## **GWR Siphon C**

Manufactured by: Scorpio Models, 3 Meads Close, NEWPORT, NP19 4NR.
Tel: 01633 279 897 E-mail: mailto:scorpio7uk@excite.com
rate this kit as: 2-4-2

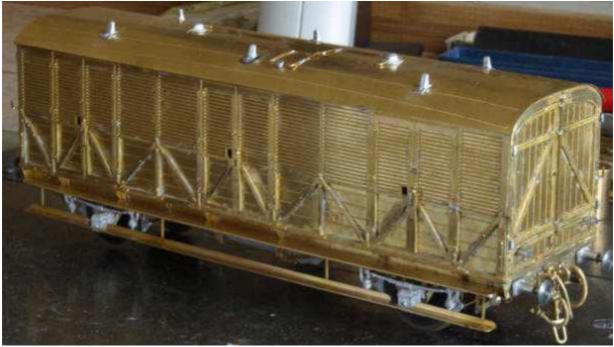
The lower steps proved to be a great disappointment. Each one is made by an ingenious

fold up from a single piece of etch that gives an excellent representation of the thick wooden step board with rounded edges and corners. Unfortunately, the drafting appears to be wrong and the cut-outs for the axle boxes did not line up at all. As can be seen from the above two pictures.

There was no way I could see that they could be modified to fit and so I scrapped them. I used some brass U channel with one side milled off instead. However, this sort of error makes me question how would a beginner have coped I wonder? (The manufacturer in a response to a published version this in the Gazette states that I had made an error in interpreting the instructions, not at all beyond the bounds of possibility. I have since contacted them to discuss this but received no reply.)
